# Service Technical Information

MODEL NO. XP-R210/SP910/SP911/V713/V714/V715J/V716C/V510/V511 V512/V513/V514/V516C/V410/V411/V412/V416C/SR311
SUBJECT Change of the PICK UP Mechanism

REF.No. :G - A0 - 059 - E0

DATE :06. SEP. 2000

Situation:

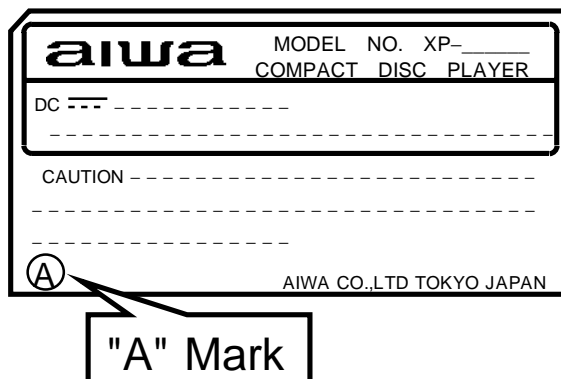
- The pickup mechanism is changed from DA23L to DA23LN.
- The pickup mechanism of only the target models is changed.
- The microcomputer is also changed because of the change of the pickup mechanism.
- A new microcomputer is exclusively used for the new pickup mechanism (DA-23LN).
- The period of production varies depending on the model.

The new pickup mechanism and microcomputer are mounted in models that will be produced in a period from September to November approximately.

Pay attention to the following points when repairing the PICK UP Mechanism, since the two types are not compatible with each other.
